KWM-380 TRANSCEIVER (622-5093-101)  
HF-380 TRANSCEIVER (622-3580-101)  
RECEIVER-EXCITER CIRCUIT CARD A3 (638-6908-001)

SERVICE BULLETIN NO 1

PRODUCT IMPROVEMENT

P/O Synthesizer Variable Reference Frequency Loop A5A2  
Figure 1

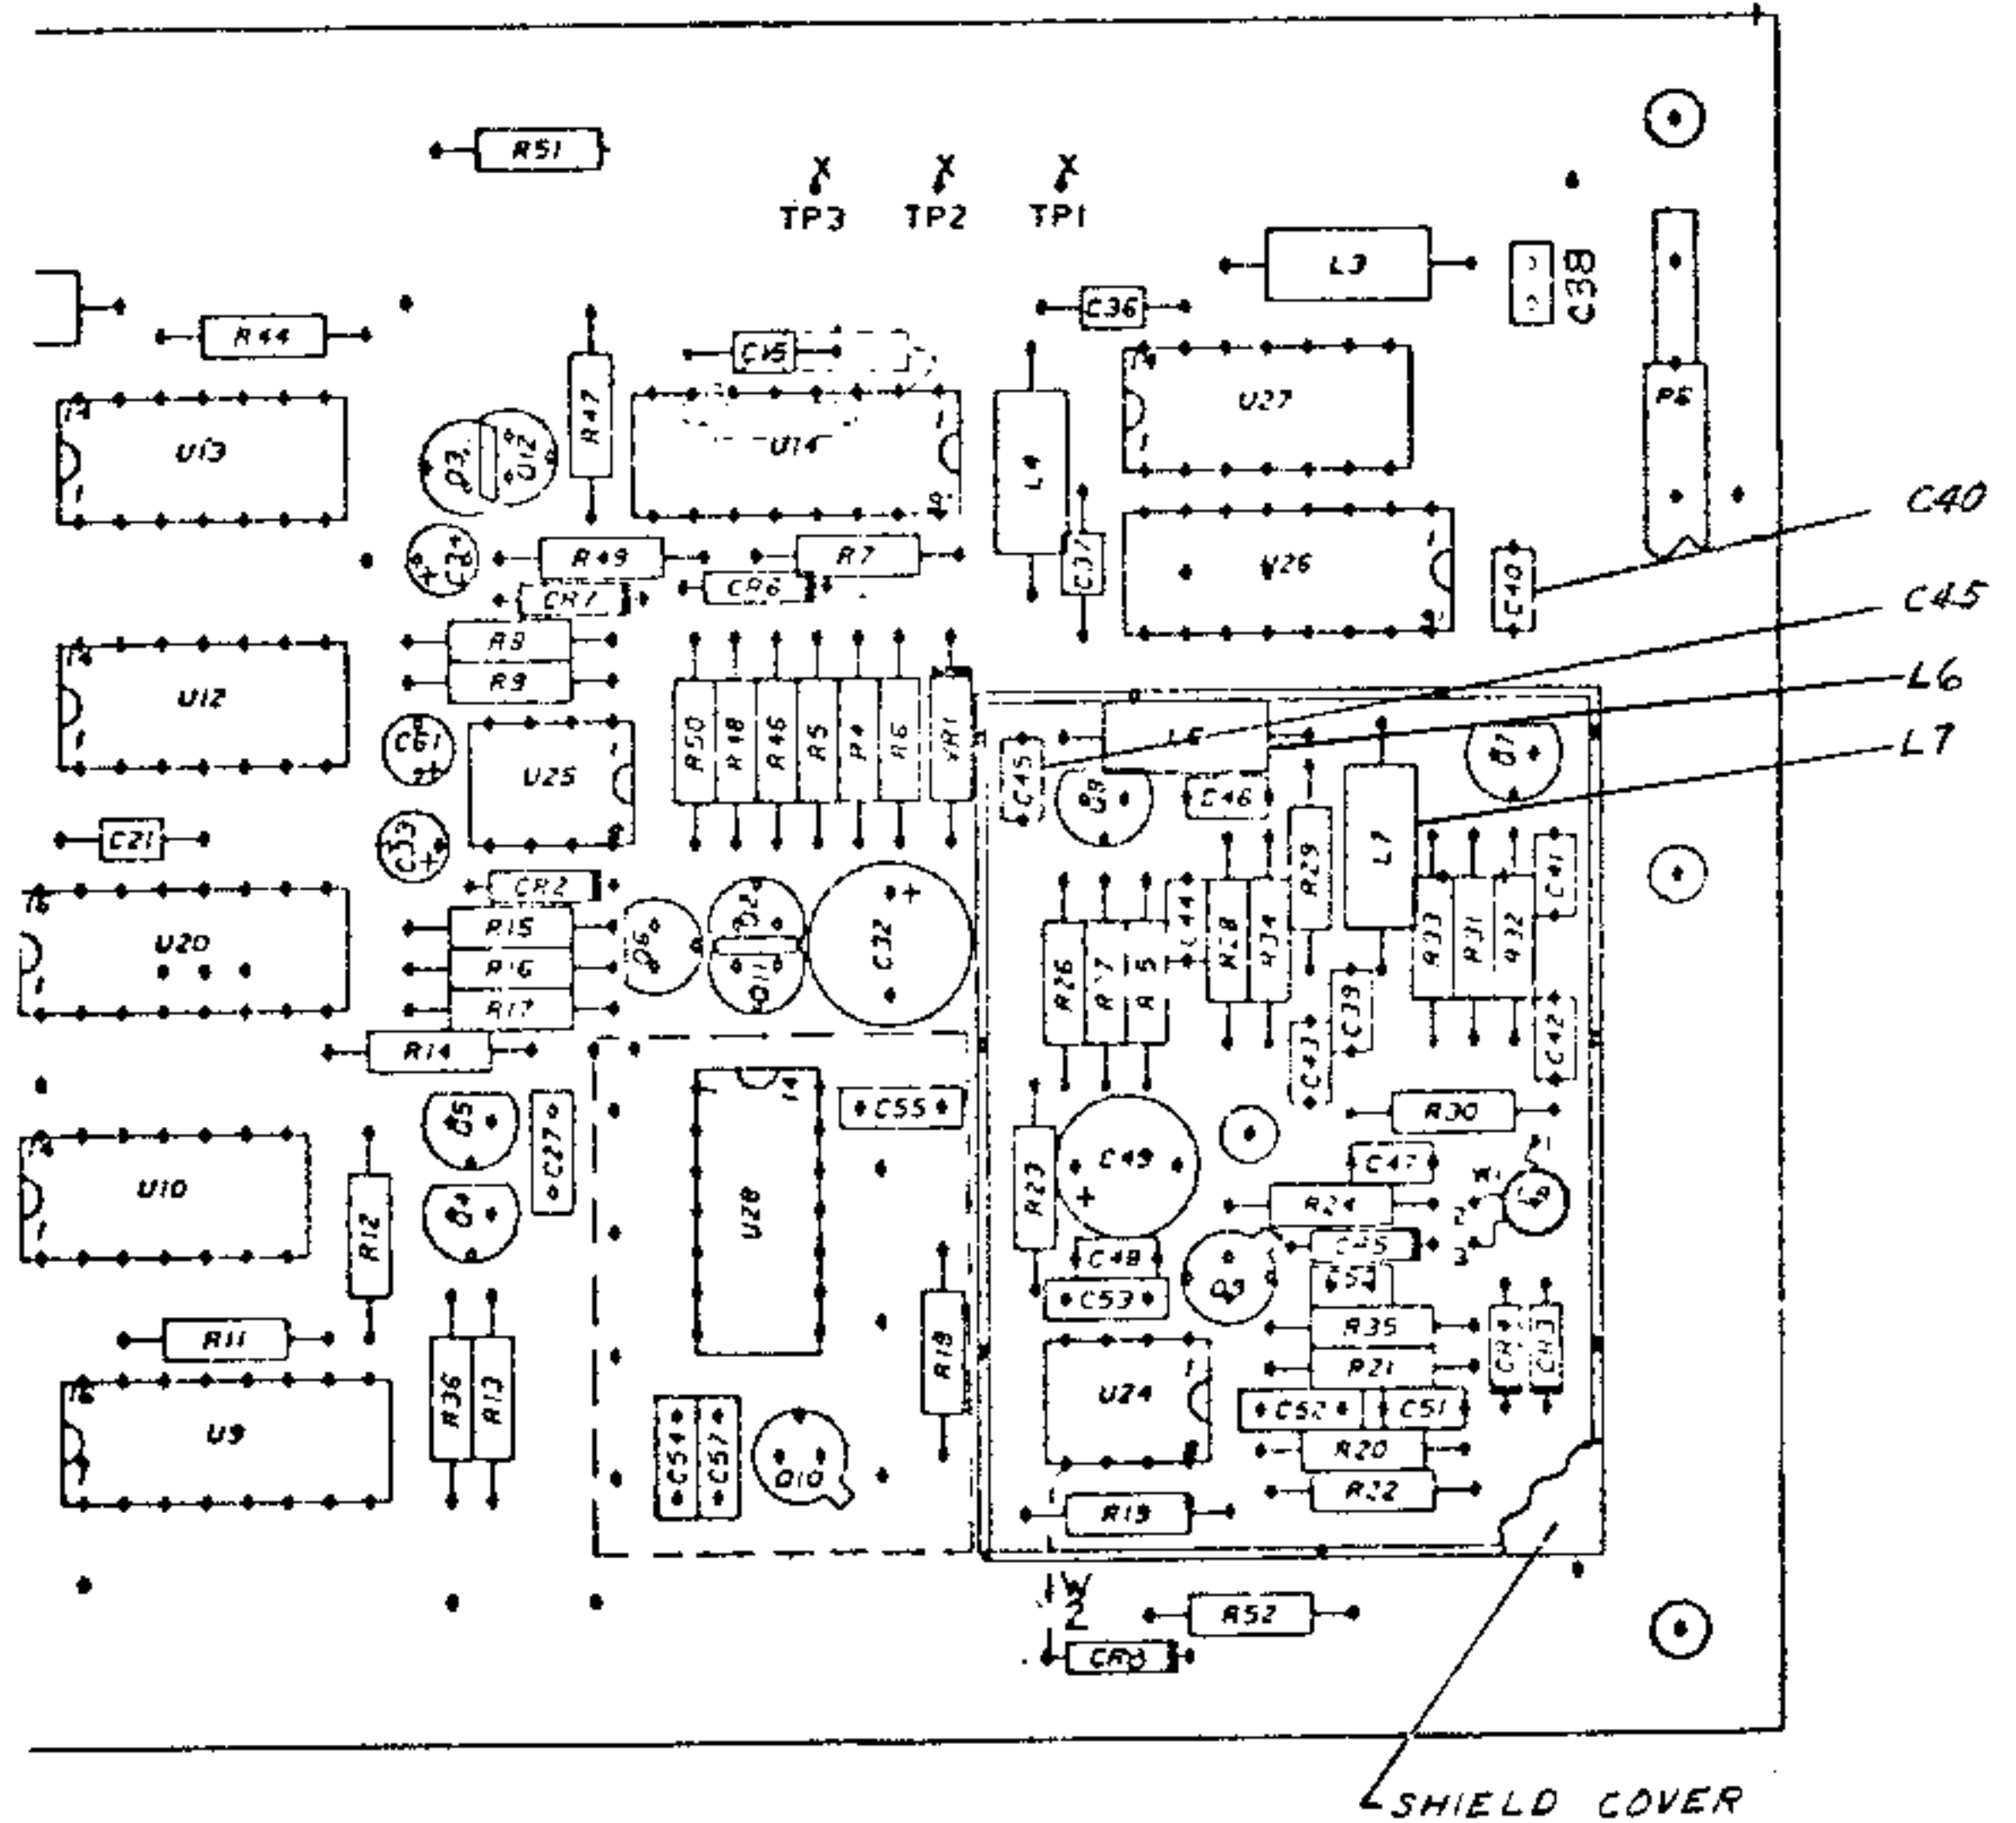
- E. Remove the screws that secure A5A2 card to the center plate. This will allow access to the rear of A5A2 for soldering purposes.
- NOTE: Refer to figure 1 while performing steps F through H.

- F. Remove shield cover by removing seven screws.
  - G. Remove coils L6 and L7 and replace them with new 0.15  $\mu$ H coils (240-1562-000).
  - H. Remove capacitors C40 and C45 and replace them with new 4 pF capacitors (912-4141-080).

KWM-380/HF-380 Front Panel, Rear View  
Figure 1

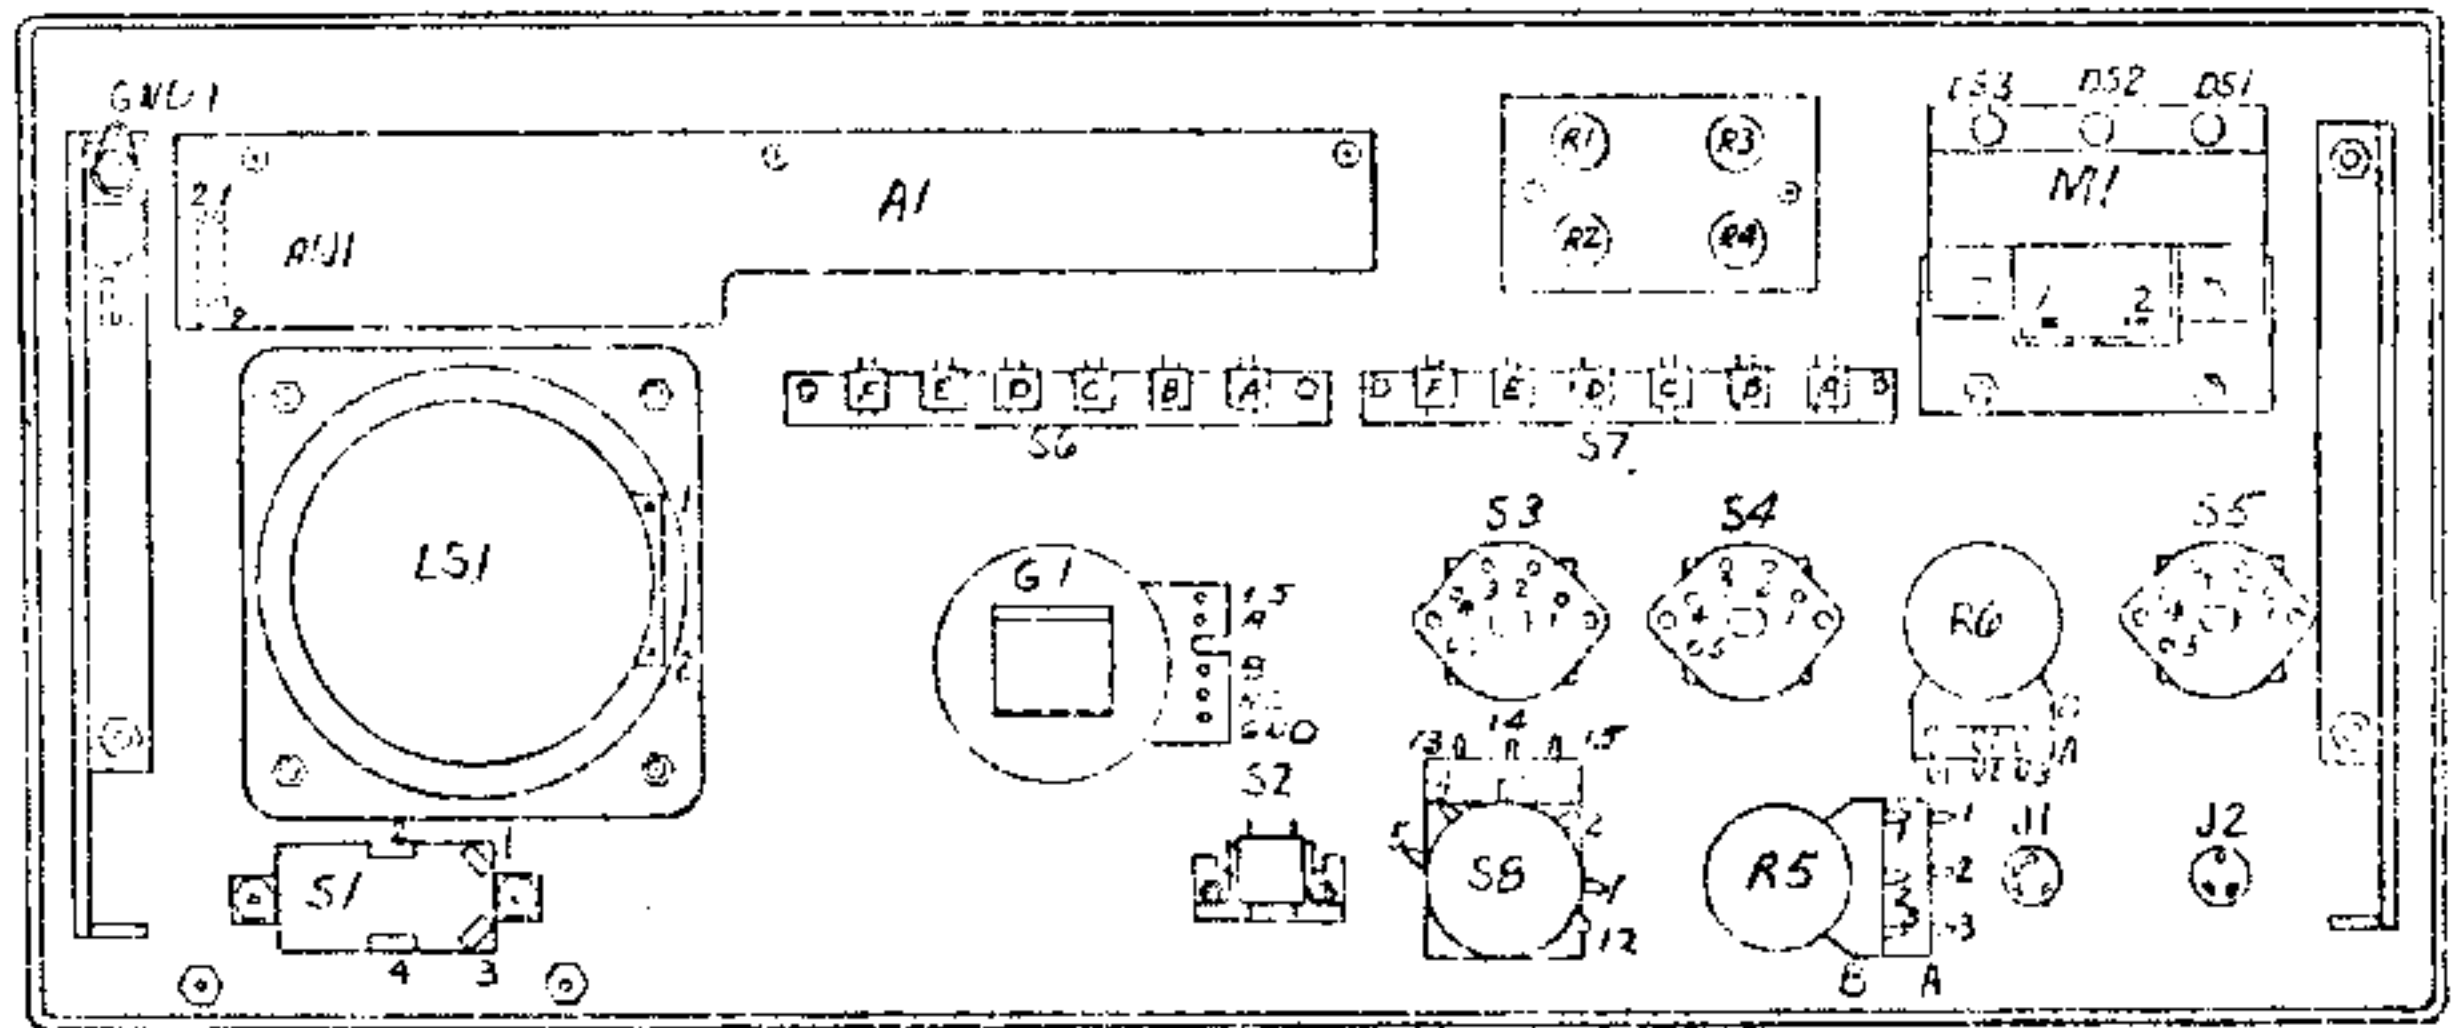
NOTE: Refer to figure 1 while performing steps D through F.
- D. Remove R5 by removing one nut and one lockwasher.
- E. TAG AND REMOVE the wires connected to tandem potentiometer R5.
- F. Connect the wires that were removed in step E to the new R5.
- G. Install new potentiometer R5 (376-0276-050) using the nut and lockwasher supplied with the pot.
- H. Solder all electrical connections.
- I. Reinstall the AF RF GAIN knobs and tighten the setscrews in each knob.
- J. Reinstall the dust cover.
- K. Mark SB 5 on the service bulletin information chart. If the transceiver does not have an information chart, install a chart (280-3778-010) near the nameplate.

KWM-380/HF-380 Front Panel, Rear View  
Figure 1

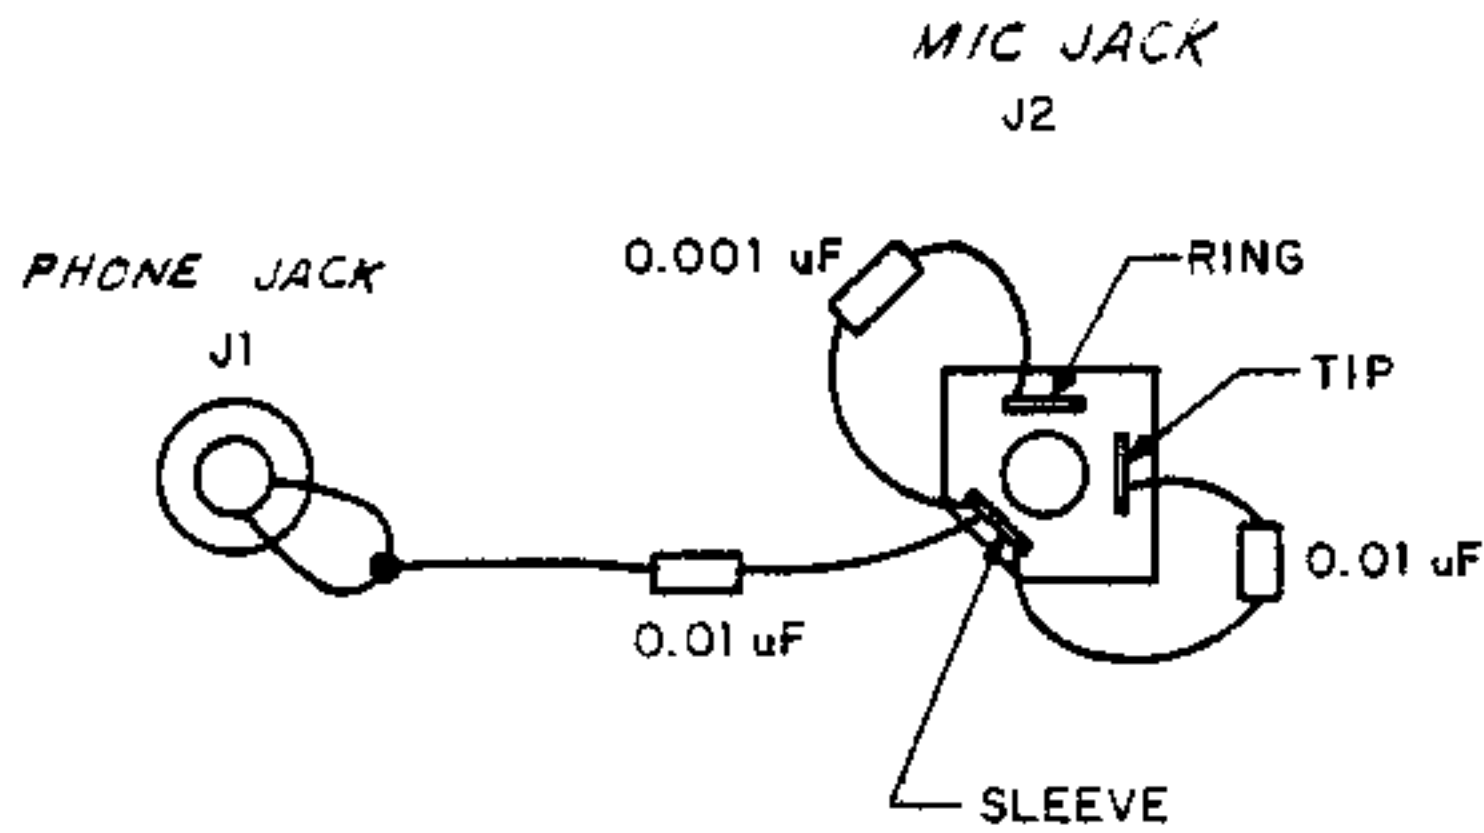
- C. Unsolder and remove the wires connected to mic jack J2 (figure 1).
- D. Remove and discard J2 by removing the nut that secures the jack to the front panel. Discard the bypass capacitors mounted on the jack.
- E. Install a new jack (647-2739-001) with the orientation shown in figure 2 using a black nut (334-1657-020).

Mic Jack J2, Orientation Diagram  
Rear View of Front Panel  
Figure 2

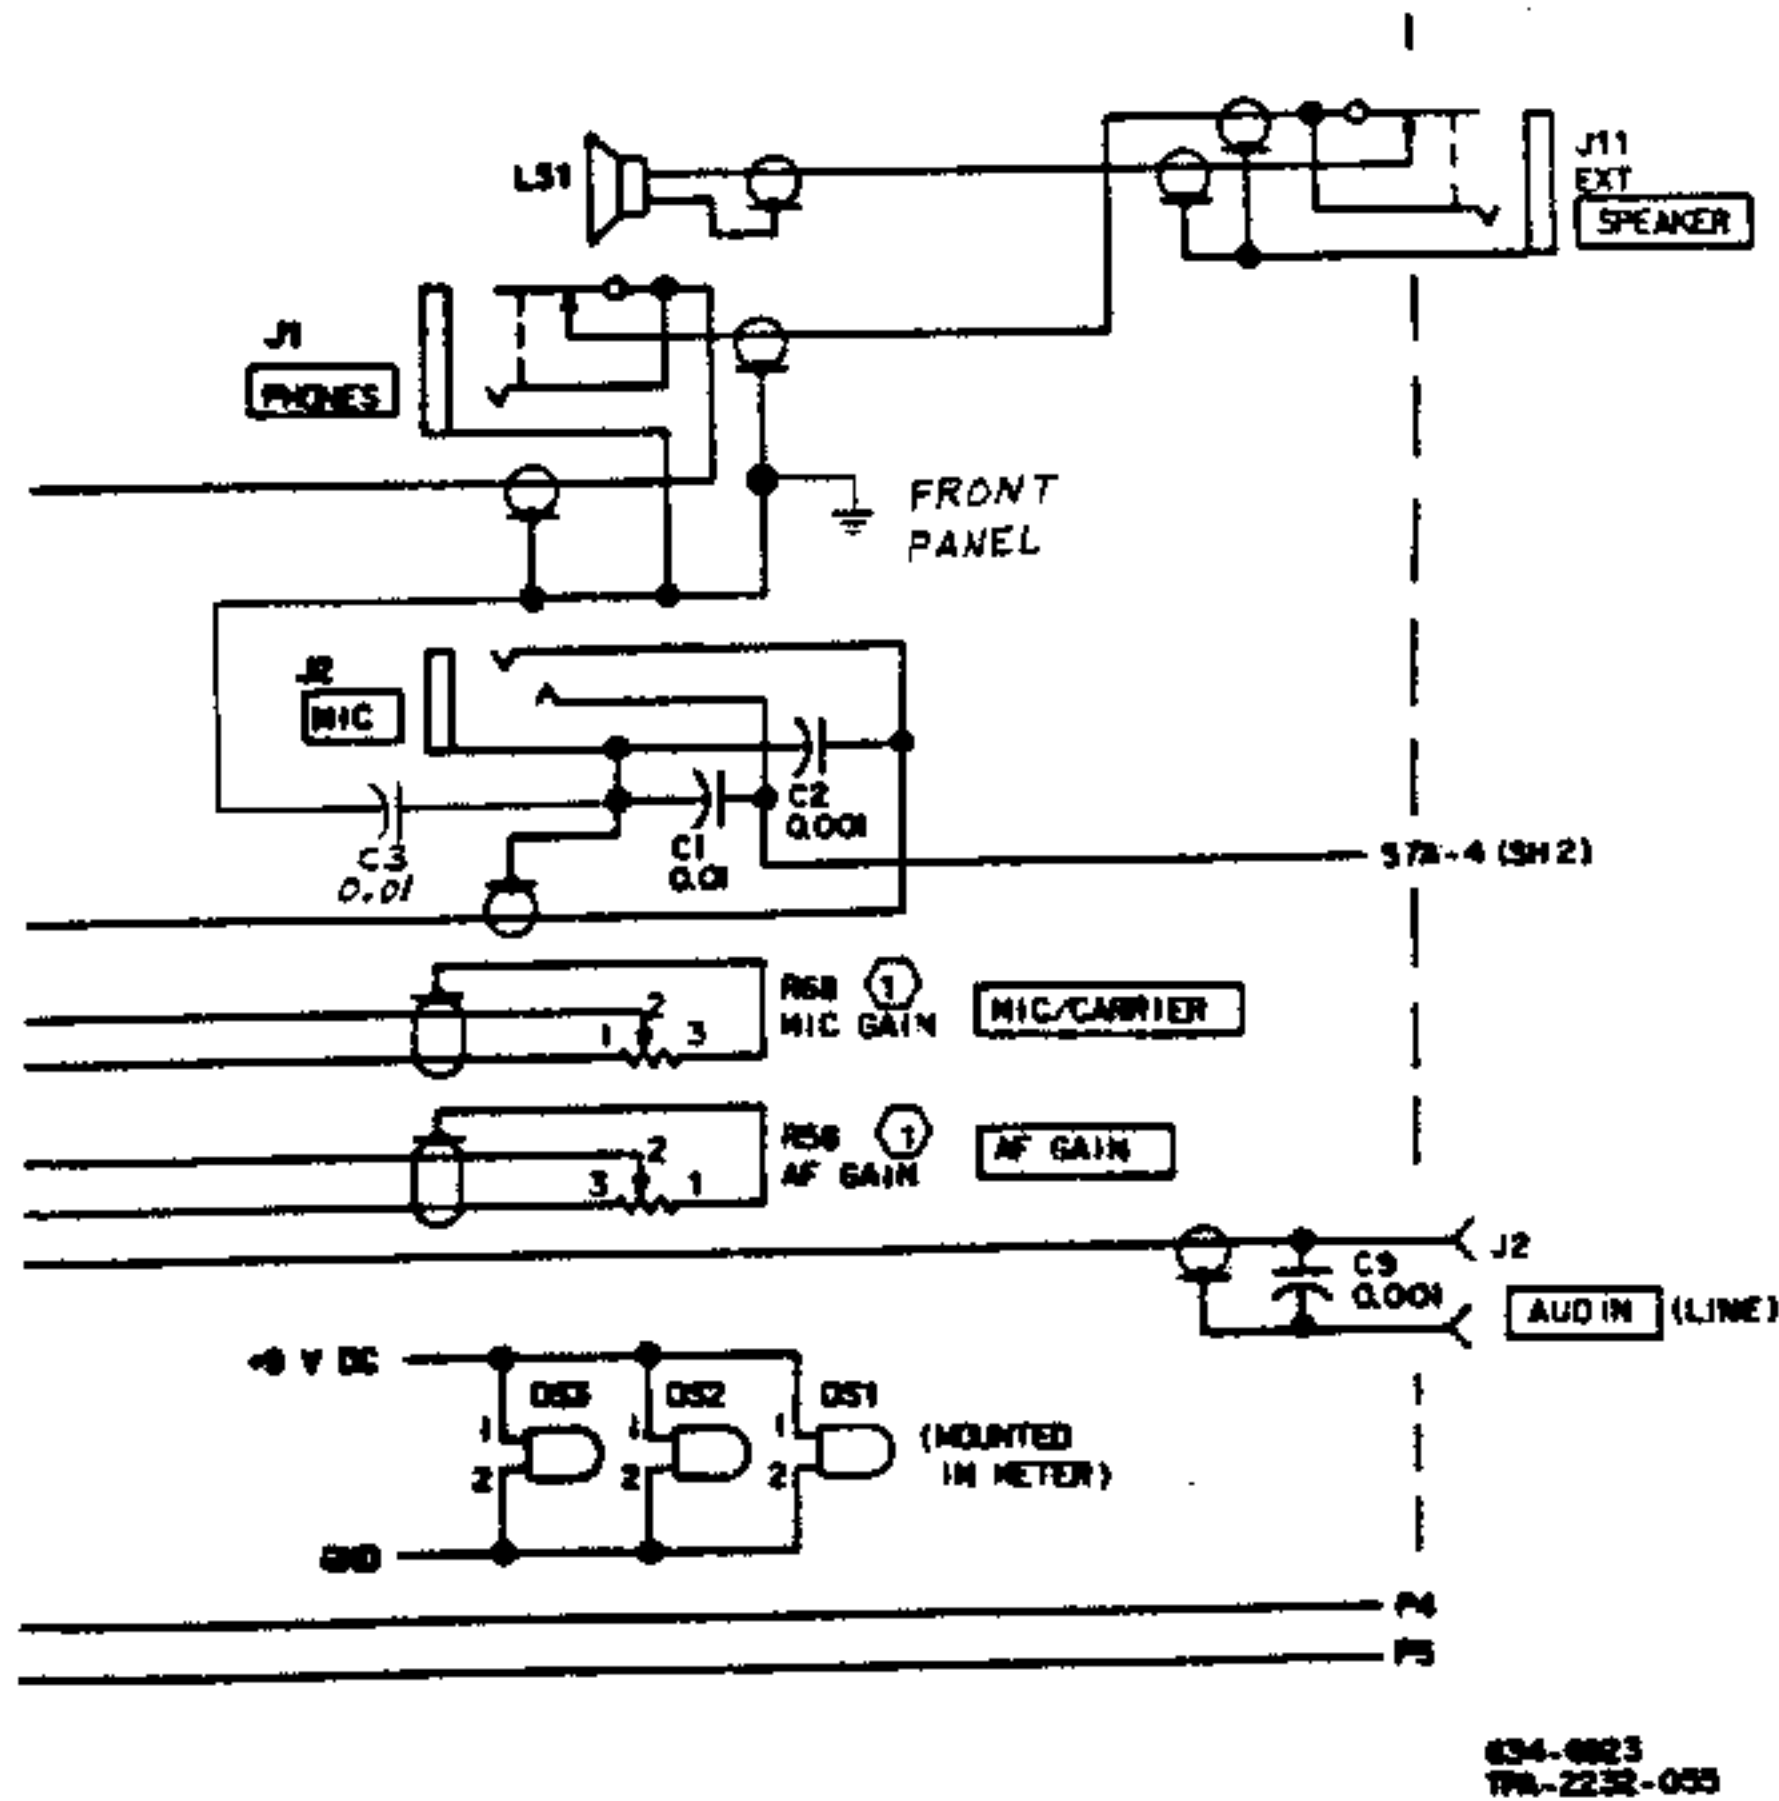
NOTE: Refer to figure 2 while performing steps F through J.

- F. Install 0.01 uF capacitor C1 (913-3331-020) between J2 tip and sleeve.
- G. Install 0.001 uF capacitor C2 (913-3331-010) between J2 ring and sleeve.
- H. Install 0.01 uF capacitor C3 (913-3331-020) between J2 sleeve and J1 sleeve (front panel ground).
- I. Reconnect the blue wire (removed in step C) to J2 tip.
- J. Reconnect the shielded cable white wire to J2 ring and black wire to J2 sleeve.
